Magnet/Syringe Separation Issues
V.B. Graves
8/16/05

This document is an initial response to the results of Peter's analysis on the attractive forces between the magnet and the steel hydraulic cylinders in the baseline syringe pump design.

Fig. 1. Existing Design

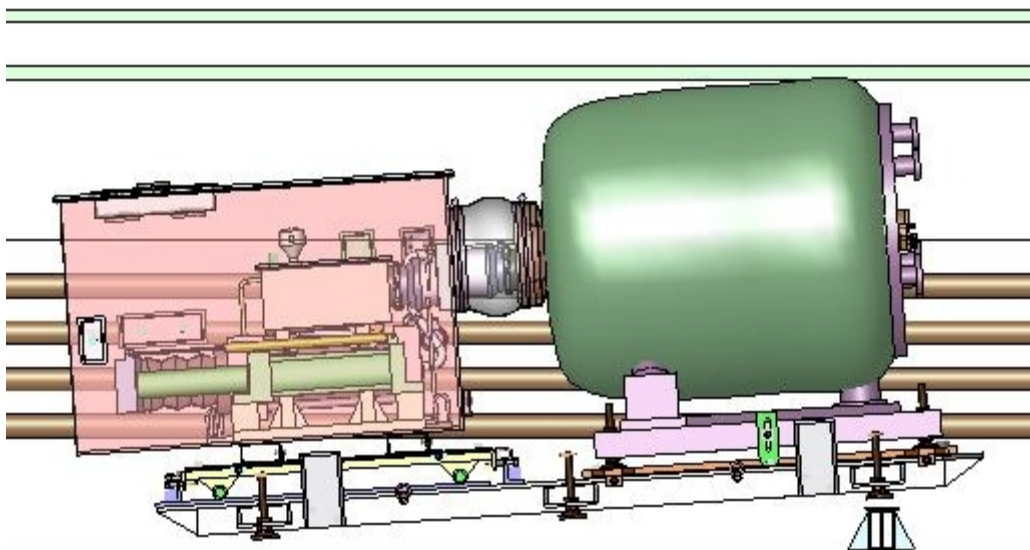
To minimize changes to the current design (Fig. 1) this separation would most easily be accomplished by increasing the length of the flexible hoses between the sump tank and the target module, keeping the sump tank and cylinders inside a secondary container box. The secondary bellows surrounding the Hg supply and return lines would necessarily lengthen as required. Conceptually this is shown in Fig. 2. This change has several implications on the design, some positive in nature and some negative. I have listed some of these below, but I'm sure that more will develop as the redesign progresses. *Those issues that deal with the cylinders must be resolved prior to the syringe pump procurement.*

Fig 2. Separated System Conceptual Layout. Intermediate hose supports not shown. Dimensions in meters.

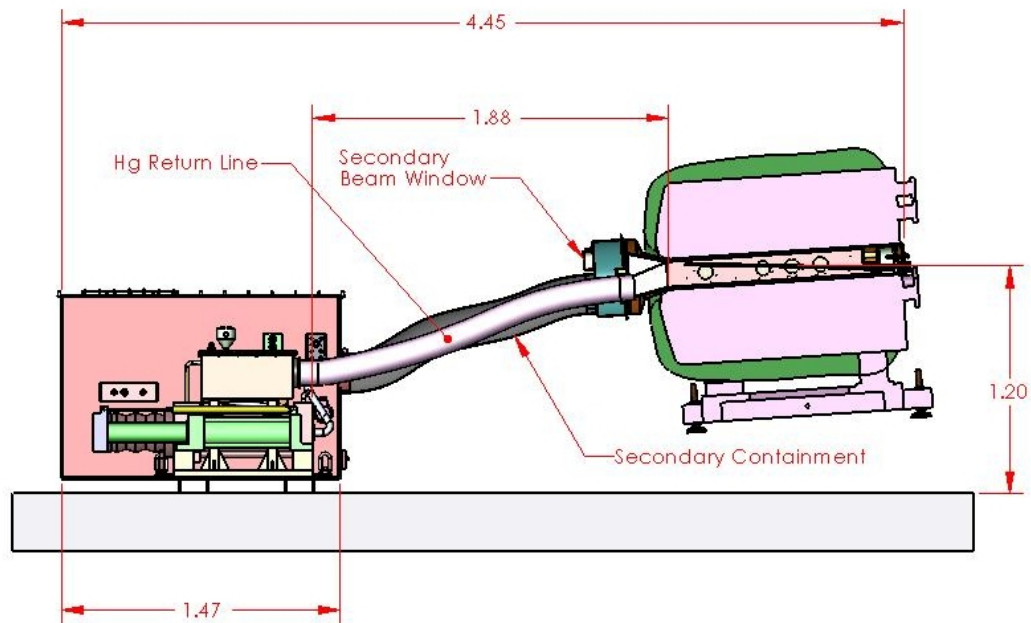
- The common baseplate cannot be extended 2m in length due to the fixed beam elevation and facility constraints both at MIT and CERN. This implies that a common baseplate is not needed. However, it is still required that the magnet be elevated, tilted, and aligned with the beam, so some sort of magnet baseplate will be necessary. Because it already incorporates a means to perform alignment adjustments, one option would be to shorten the current baseplate so that it only supports the magnet.

- With flexible hoses, the syringe does not have to be tilted and may sit directly on the floor (or a mobile baseplate).
- The syringe system no longer has to be directly in line with the magnet or beam, which would allow some flexibility in positioning. This may be beneficial during integrated tests at MIT.

- With 1.5m – 2m of flex hose, the target module might be manually inserted into magnet, so syringe system does not require rolling cart. Estimated weight of the target module is 100-150 lbs.

Fig. 4. Existing target module bracing method

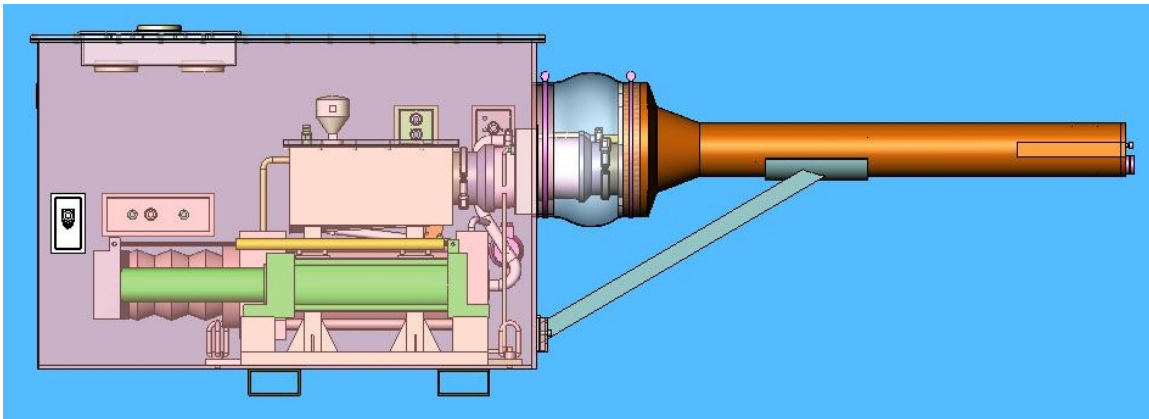
- Because the syringe pump & containment box would be positioned below the beam, the downstream secondary beam window would move to the target module rather than the secondary containment box.
- Downstream end of target module would require changes to accommodate different secondary containment.
- Supporting the target module off of the secondary containment box from 2m away is not practical (see Fig. 4). Secondary containment baseplate could have provisions for storage of target module.
